Access Compliance Report Public Rights-of-Way (Curb Ramps)

Main Street: HUNTER_LN Cross Street: MADISON_AVE Location: NE

ADA ID: RPRK220203152543 Ramp Type: Type 4 - Parallel Initial Pass/Fail: Pass Overall Compliance: No Severity Score: 0

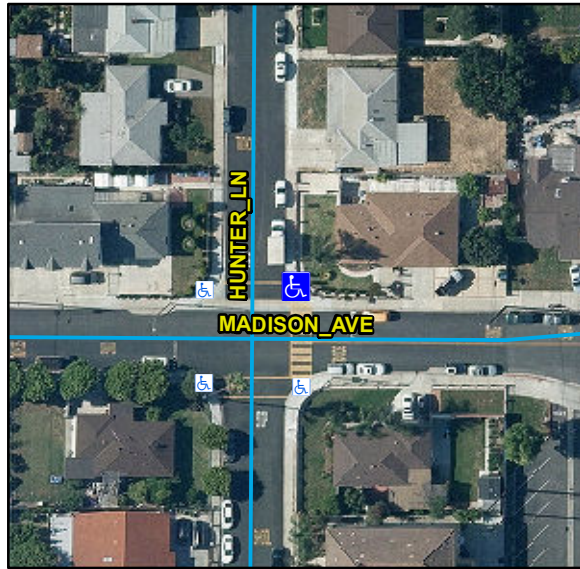
R304.5.3, STD 1115

Crossing 1 Slope (%)	1.4		Crossing 2 Slope (%)	6.3
	Crossing 1 Cross Slope (%)	0.5		Crossing 2 Cross Slope (%)	0.3
Yes	Gutter Ponding	No	Yes	Curb Slope	1.8
Yes	Gutter Lip Height (in)	0		Road Run Slope (%)	0
Yes	Gutter Run Slope (%)	1.8		Road Cross Slope (%)	1.1
No	Gutter Cross Slope (%)	2.2	Yes	Perpendicular Joint Present	Yes
Yes	Overall Surface Condition	Acceptable			
	Cross Gutter Present?	Yes		Spandrel Present?	Yes
	Replace Cross Gutter?	No		Replace Spandrel?	No

Remove & Replace Gutter.
